HISTORIC AND DESIGN REVIEW COMMISSION

HDRC CASE NO: 2018-097

ADDRESS: 808 E CARSON

TYPE OF WORK: Construction of two, multi story residential structures and a detached garage

WEST ELEVATION

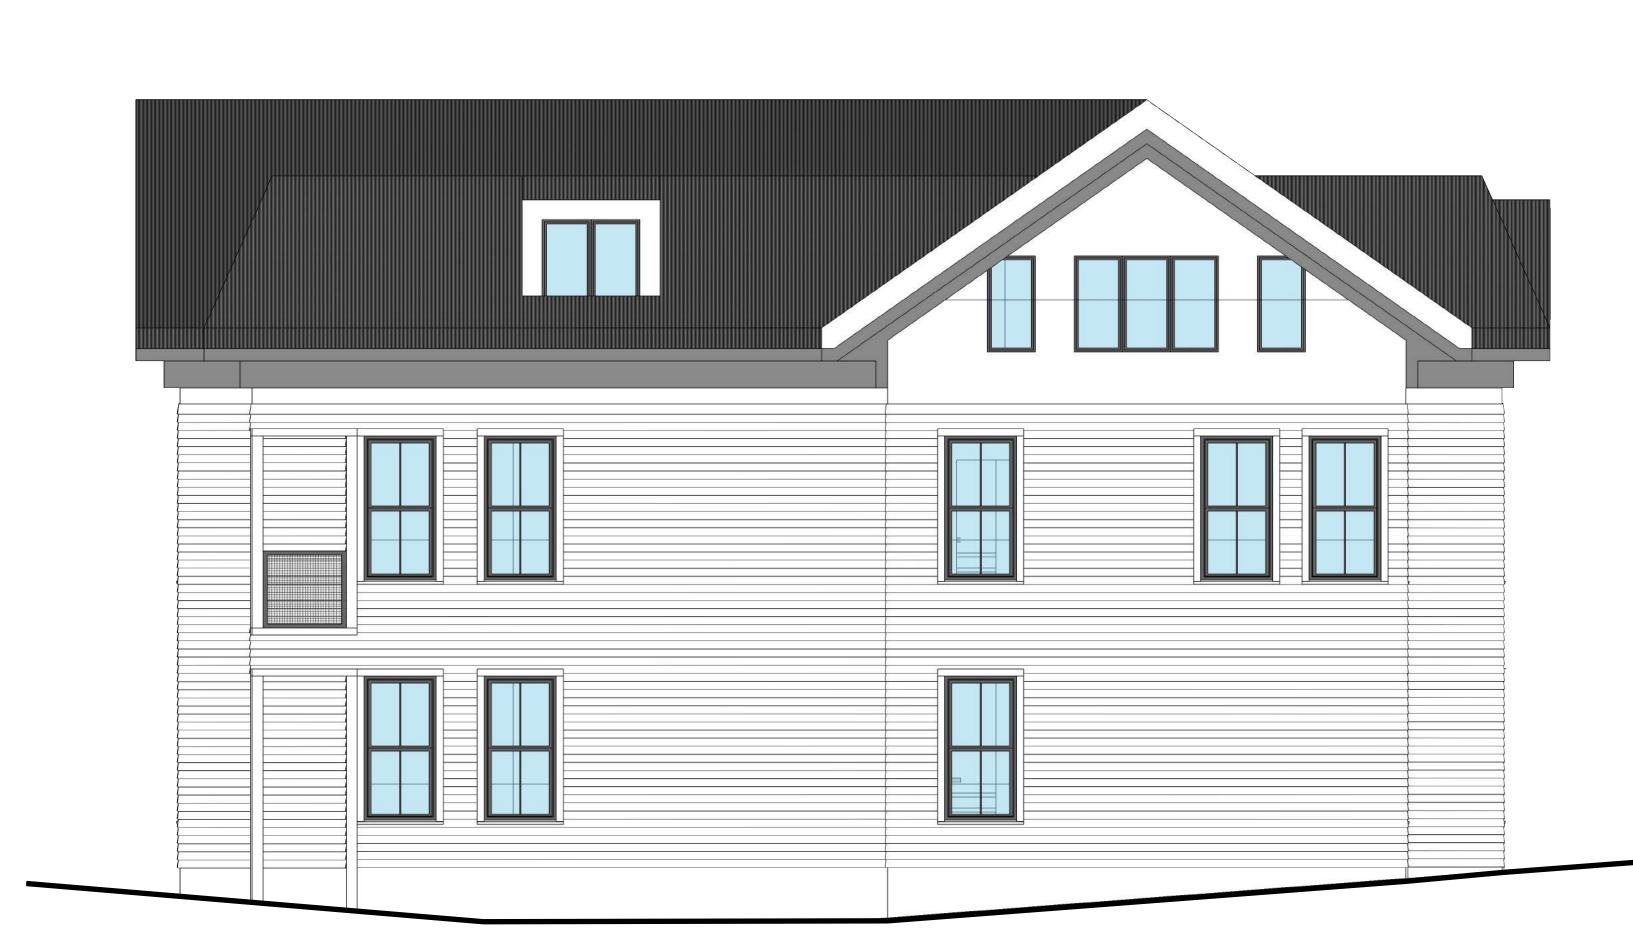
- e. SCALE & MASS (E Carson) Per the Guidelines for New Construction 2.A.i., a height and massing similar to historic structures in the vicinity of the proposed new construction should be used. In residential districts, the height and scale of new construction should not exceed that of the majority of historic buildings by more than one-story. This block of E Carson features seven residential structures, three of which feature two stories in height. While there are examples of historic structures nearby that feature multiple stories in height, the proposed new construction features a total height of approximately 33 feet (E Carson structure). Staff finds the proposed height of the structure to address E Carson inconsistent with the Guidelines. Additionally, the proposed massing features solid wall planes at locations where historic structures feature voids for porches.

- h. ROOF FORM The applicant has proposed roof forms that include gabled and hipped roofs. Generally, these proposed roof form are appropriate and are found historically throughout the Government Hill Historic District; however, the applicant has also proposed roof forms which resemble mansard roofs, a form not found within the district. Staff finds that the proposed roof forms should more closely relate to hipped roofs.

- m. ARCHITECTURAL DETAILS The applicant has proposed structures that generally feature massing that is appropriate for this block; however, staff finds that architectural details should be addressed prior to receiving a Certificate of Appropriateness, such as recessed porch massing and façade depth. The applicant has proposed an architectural form features forms and profiles found commonly in the historic, Folk Victorian style; specifically, porches on Folk Victorian structures are recessed behind the massing of protruding bays.

- n. ARCHITECTURAL DETAILS (PORCHES) The proposed new construction does not feature porch massing, a primary architectural element of Folk Victorian architecture. The applicant has proposed balconies, which include recessed massing, but in regards to depth and facade placement, these are not consistent with the Guidelines.

- i. That the applicant incorporate deeper porch massing into the front façade of the proposed primary structure that is to front E Carson as noted in findings m and n.

- ii. That the applicant work to incorporate roof forms that are more closely related to hipped roofs found within the district, rather than mansard roofs.

Project Number: 201801 Sheet Contents: Garage

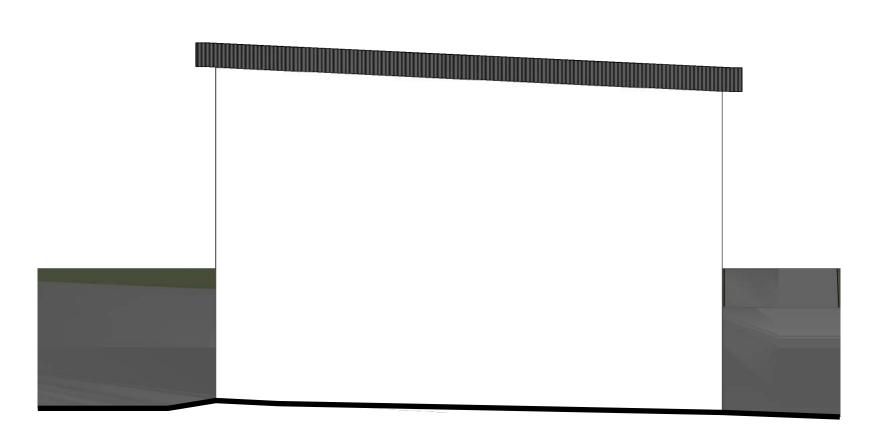
- r. ACCESSORY STRUCTURE Between the proposed residential structures, the applicant has proposed to construct an accessory structure to serve as covered automobile parking. Staff finds this to be appropriate; however, the structure should feature materials that match those proposed on the residential structures.

- ii. That materials follow the specification as noted in finding k.
- iii. That all mechanical equipment be screened from view at the public right of way on E Carson and Colita as noted in finding o.
- iv. That the applicant submit foundation documents noting a foundation height that is consistent with the Guidelines as noted in finding g.
- 3. Staff recommends approval of request item #3 with the following stipulations:
 - i. That the structure feature materials that match those proposed on the two residential structures.

Sheet Contents:
Carriage House
Elevations

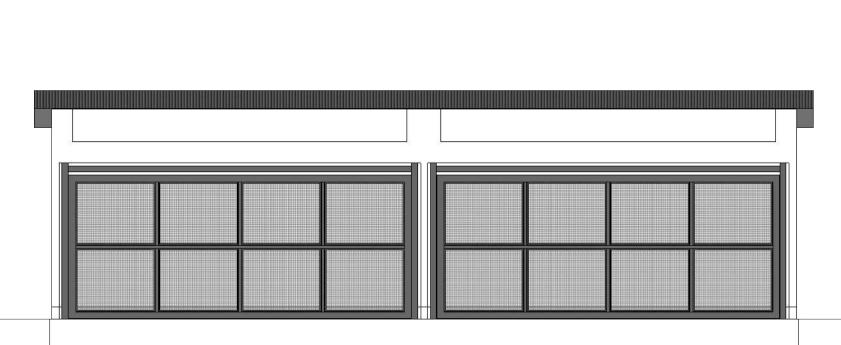
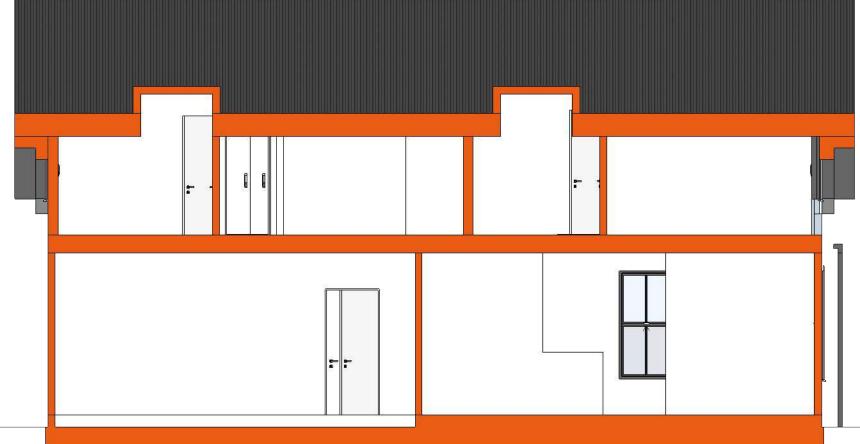
- f. SCALE & MASS (Colita) The applicant has reduced the proposed massing of the rear unit that is to address Colita to feature an overall height of 22'. The proposed rear structure's massing is subordinate to that of the proposed primary structure and generally consistent with the Guidelines.

- 2. Staff recommends final approval of request item #2 with the following stipulations:
 - i. That a double-hung, one-over-one wood windows or aluminum-clad wood windows be used. Meeting rails must be no taller than 1.25" and stiles no wider than 2.25". White manufacturer's color is not allowed, and color selection must be presented to staff. There should be a minimum of two inches in
